AGENDA – Planning Commission Meeting

**Concept Plan
Fox Hollow Neighborhood 4
August 29, 2024
Public Meeting**

APPLICATION REVIEW CHECKLIST

Date Received:	8/2/2024
Date of Review:	8/7/2024
Project Name:	Fox Hollow N4
Project Request / Type:	Concept Plan
Meeting Type:	Public Meeting
Applicant:	Pulte Homes/Grnobl Co.
Owner:	SPC Fox Hollow, LLC and Cardinal Land Holdings IV, LLC
Location:	Approx. 87 W. Village Parkway
Major Street Access:	Village Parkway
Parcel Number(s) and size:	59:012:0178/10.28 AC 59:012:0180/09.90 AC 59:012:0186/37.66 AC
Land Use Designation:	High Density Residential/Community Commercial
Parcel Zoning:	R1-10/CC
Adjacent Zoning:	R1-10
Current Use:	Vacant
Adjacent Uses:	Low Density Residential
Previous Meetings:	N/A
Previous Approvals:	N/A
Type of Action:	Administrative
Land Use Authority:	City Council
Future Routing:	DRC, Planning Commission & City Council
Planner:	Austin Roy/Senior Planner

SHEET NUMBER
C200

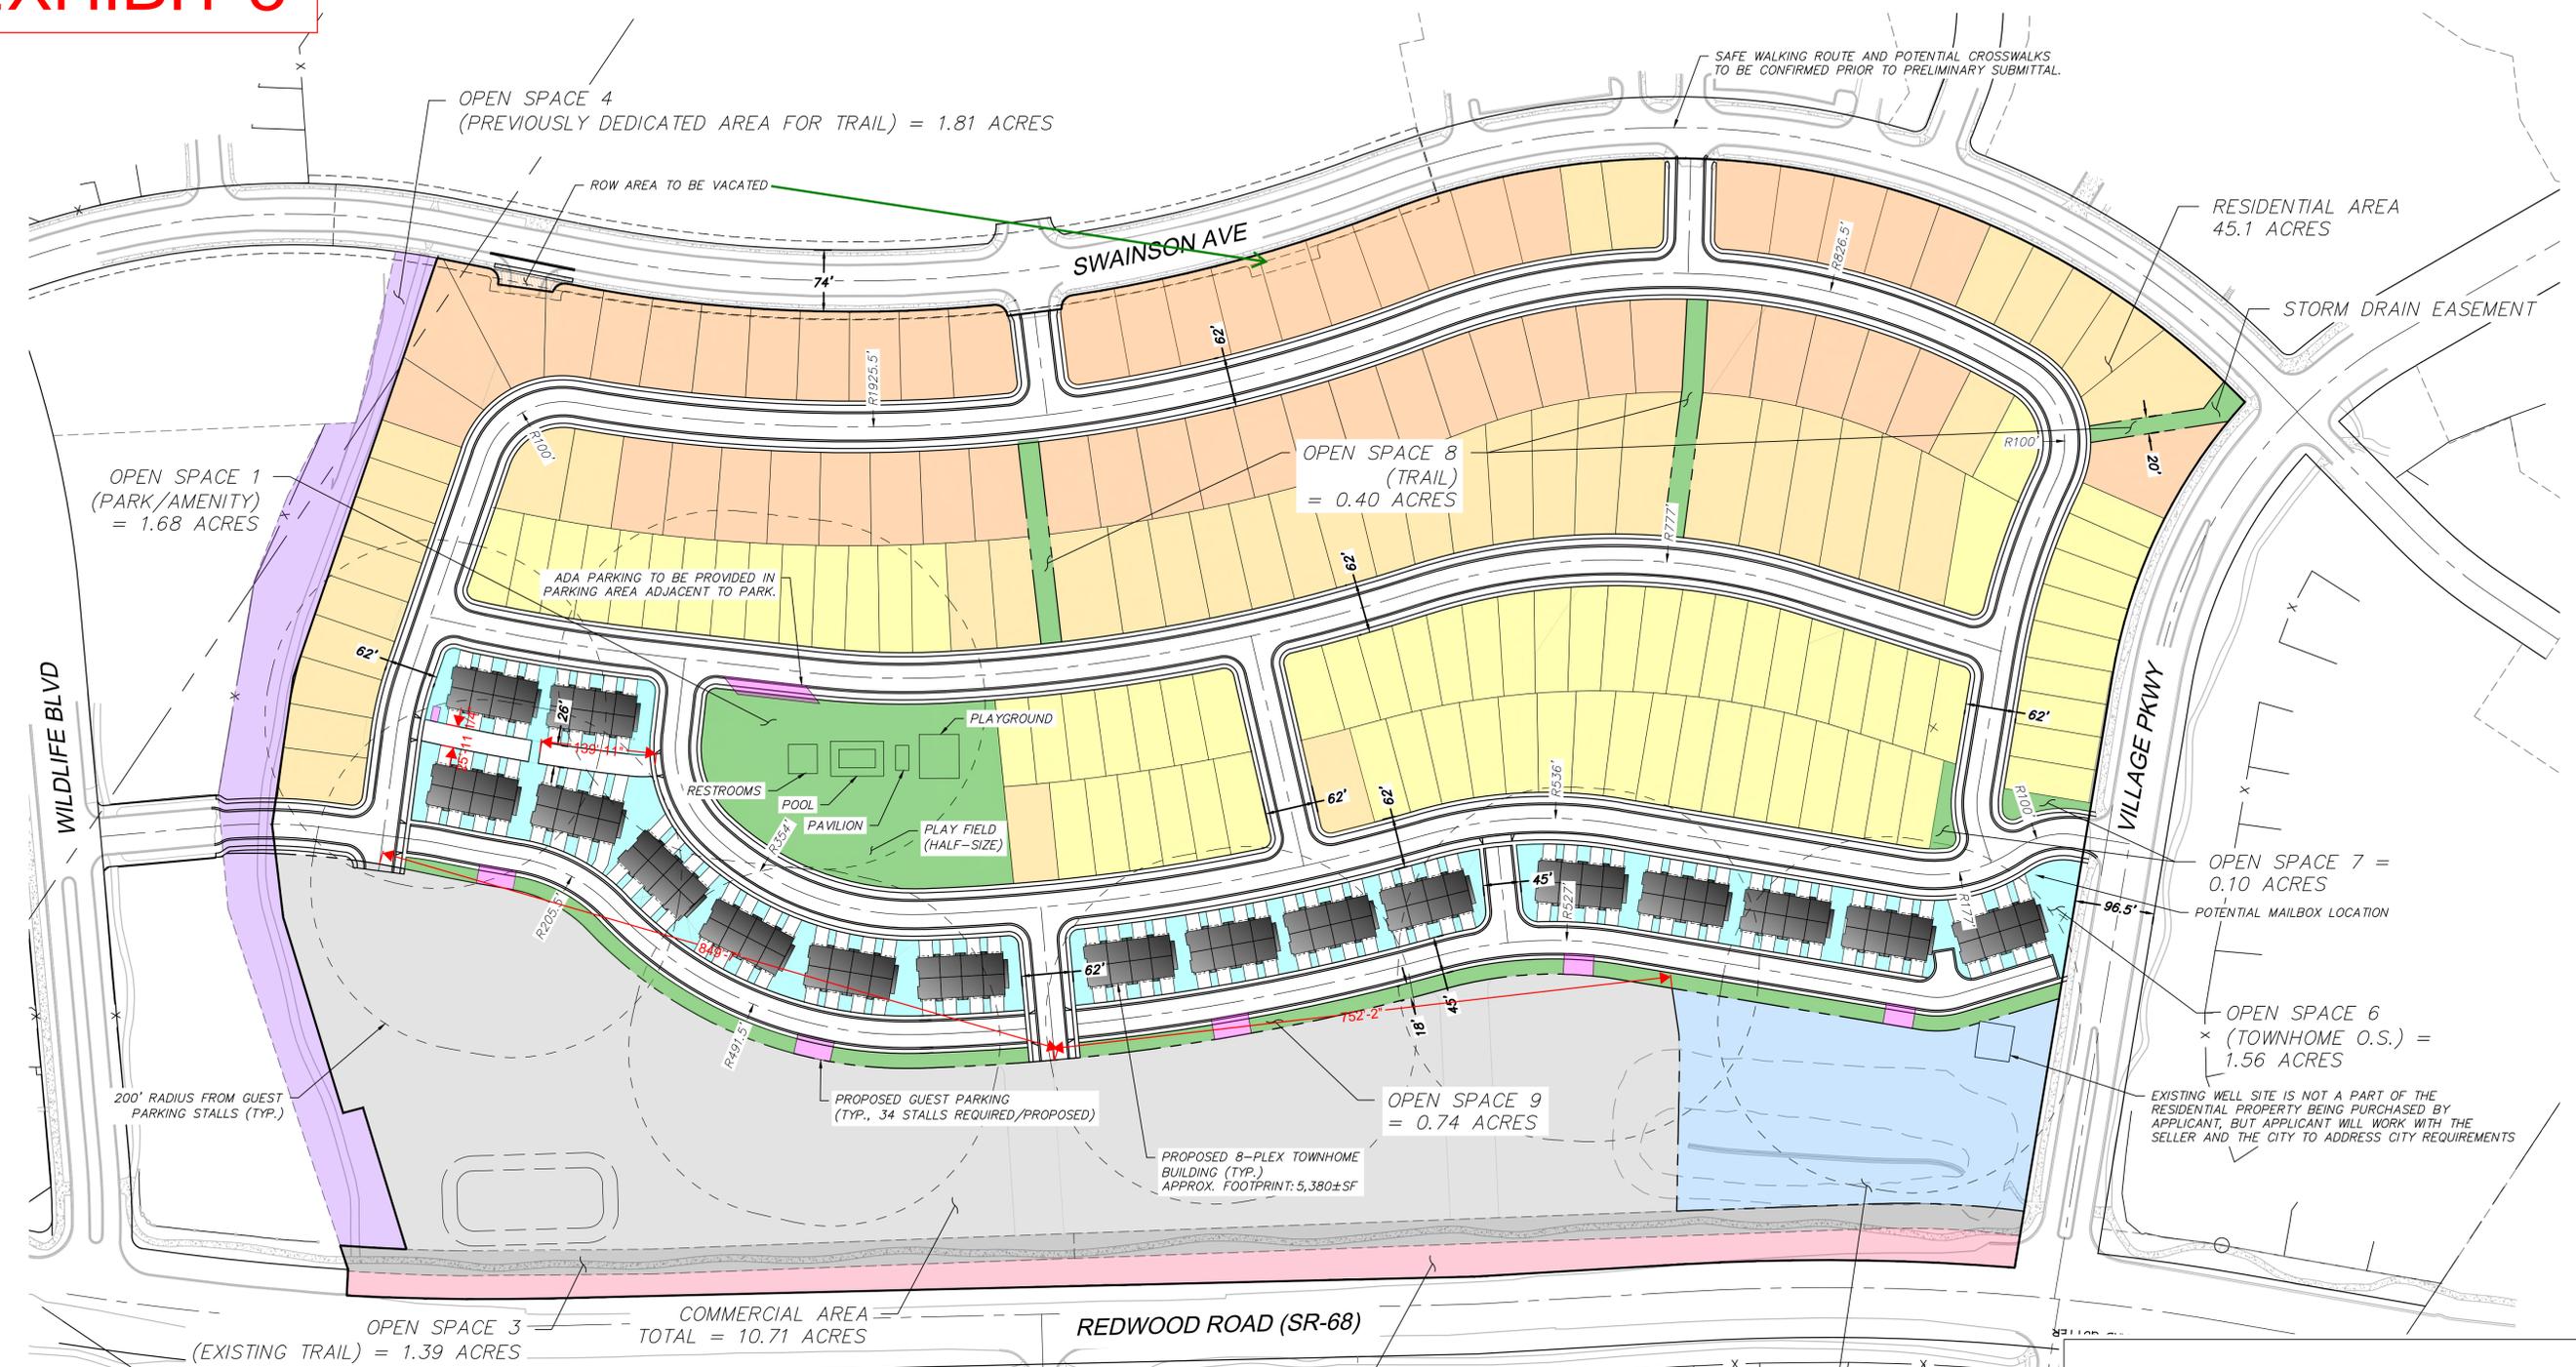
- Need to provide a conceptual layout for the commercial portion.
- City has concerns that the eastern road is private, commercial properties will need access to the signals. Once way to solve this is to make this road public.
- Need to install a fence abutting open space drainage area.
- Verify compatibility with Safe Walking routes to the schools.
- Shall comply with all requirements found in the Fox Hollow MDA.
- Well site should be dedicated to the City, with an access off of Village Pkwy.
- Detention area should be landscaped with the first phase of the project.
- UDOT has determined that a traffic signal is required at the intersection of Village Parkway and Redwood Road. Will need to be installed with this development.
- Variations subject to City Council approval include: 1) Lot Width, 2) Lot Size, 3) Height, and 4) Flat Roofs.

Concept Plan Application Requirements		
Regulation	Compliance	Findings
A completed application and affidavit, form, and application fee.	Complies.	<i>Received.</i>
Plat/Parcel Map of the area available at the Utah County Surveyor's Office.	Complies.	<i>Received.</i>
Proposed changes to existing zone boundaries, if such will be needed	N/A.	
Conceptual elevations and floor plans, if available	Complies.	<i>Received.</i>
Drawn to a scale of not more than 1" = 100'	Complies.	<i>1"=100'</i>
Proposed name of subdivision, cleared with the County Recorder to ensure the name is not already in use	Complies.	<i>Fox Hollow Neighborhood 4.</i>
Name of property if no subdivision name has been chosen. This is commonly the name in which the property is locally known	Complies.	<i>Fox Hollow Neighborhood 4.</i>
Locations and widths of existing and proposed streets and right-of-ways	Complies.	<i>C200.</i>
Road centerline data including bearing, distance, and curve radius	Complies.	<i>C200.</i>

Configuration of proposed lots with minimum and average lot sizes	Complies.	<i>C200.</i>
Approximate locations, dimensions, and area of all parcels of land proposed to be set aside for park or playground use or other public use, including acreages, locations, and percentages of each and conceptual plan of proposed recreational amenities	Complies.	<i>C200.</i>
Those portions of property that qualify as sensitive lands per Section 19.02.02., including acreages, locations, types, and percentages of total project area and of open space	N/A.

developments, and from buildings to the public sidewalk to minimize the need to walk within the parking lot among cars.		
All pedestrian connections shall be shown on the related site plan or plat.	Complies.	<i>C200.</i>
<p>Parking Areas: On-site parking shall be located primarily to the sides or rear of the building. Variations may be approved by the Land Use Authority, subject to the following criteria:</p> <ul style="list-style-type: none"> i. The use is a big box with outparcels helping to screen parking, or ii. At least 50% of the parking is located to the side or rear of the building, or iii. A safety issue is created by locating parking to the side or rear as verified and documented by the Saratoga Springs Police Department. For example, the parking will be entirely concealed from view by existing walls or buildings, or iv. That portion of development that lies within the Waterfront Buffer Overlay, or v. The development is Office, Warehouse/Flex space and when loading docks are not adjacent to a public right-of-way. Exception: when a lot with Office, Warehouse/Flex space is adjacent to more than one public street, loading docks may face the lower classification of the streets. 	N/A.
